**MONTGOMERY VILLAGE FOUNDATION
ARCHITECTURAL REVIEW BOARD**

April 3, 2018

19409 Faber Court (The Heights, Stedwick)

“Black” Security storm door and fence gate review for criteria change

STORM DOOR

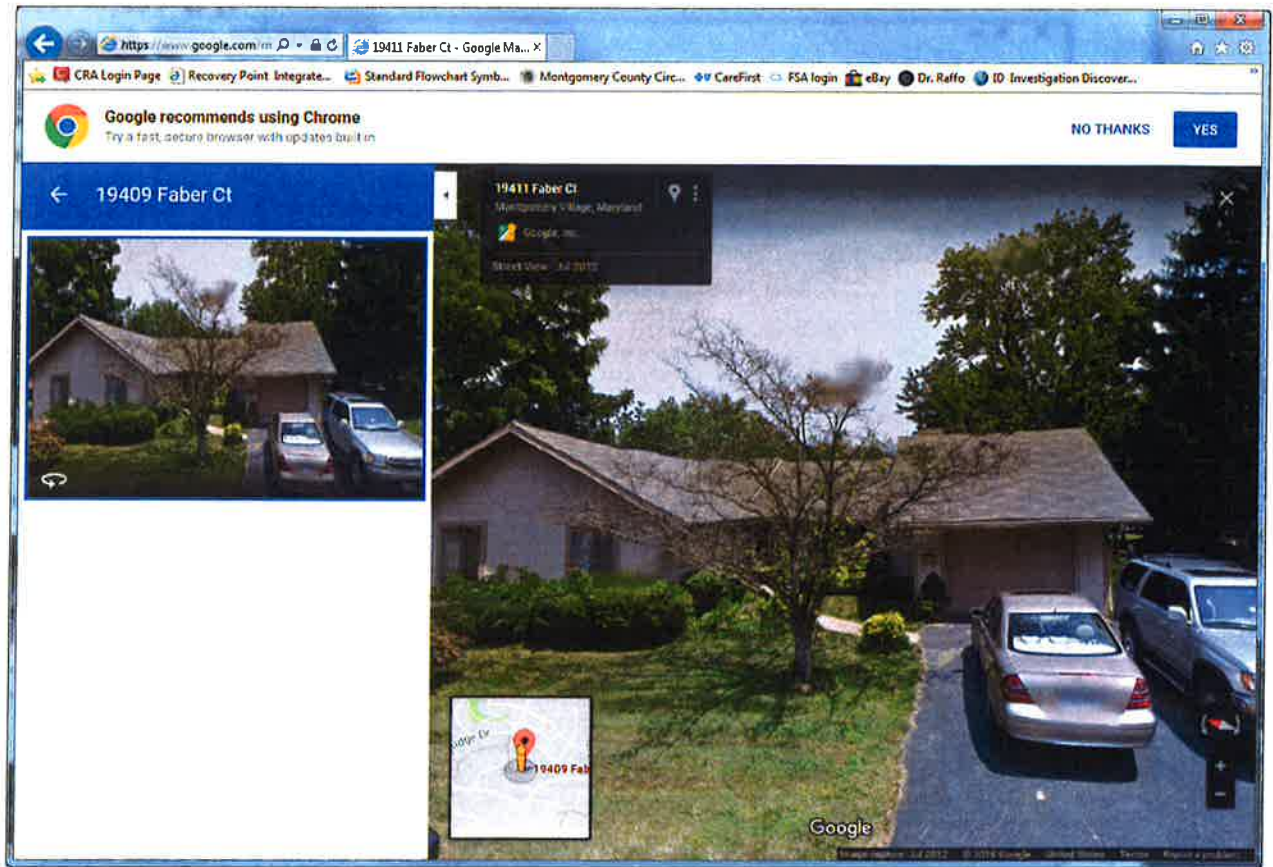
Staff Notes: In December of 2017, a scheduled inspection was performed on the property at 19409 Faber Court in The Heights sub-division of Stedwick. Violations were noted on the house. The existing “Black” security style storm door was installed without prior approval from the ARB. The homeowner was notified on January 18, 2018 that the existing “Black” security style storm door was in violation and it would be reviewed in house with the Design Consultant.

On February 6, 2018 the homeowner submitted a letter of appeal for the existing “Black” security style storm door requesting to retain the security style storm door. The homeowner stated that this “Black” security style storm door was existing in July of 2014 when he purchased the home however, and had been in place prior to that since 199 and was not notified that it was in violation until December of 2017.

The AS staff and the Design Consultant reviewed the security style storm door appeal in a routine in-house review meeting on March, 2018 and it was denied. The homeowner was asked to paint the “Black” security style storm door to match the front door paint color to be compliant with the community criteria. The homeowner requested to retain the existing “Black” security style storm door and asked for an appeal of the violation to be reviewed by the ARB.

Recommendation: The Design Consultant recommends denial of the existing “Black” security style storm door. He recommends that the homeowner paint the security storm door to match the current front door color so it will be in compliance with the community criteria .

Arched Gate OR Flat Top Gate

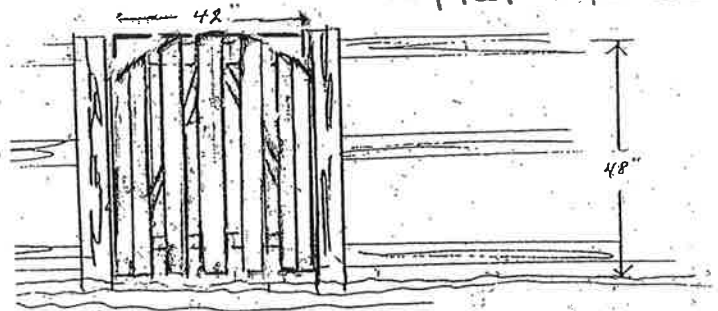
Review of flat top gate style for The Heights of Stedwick community criteria
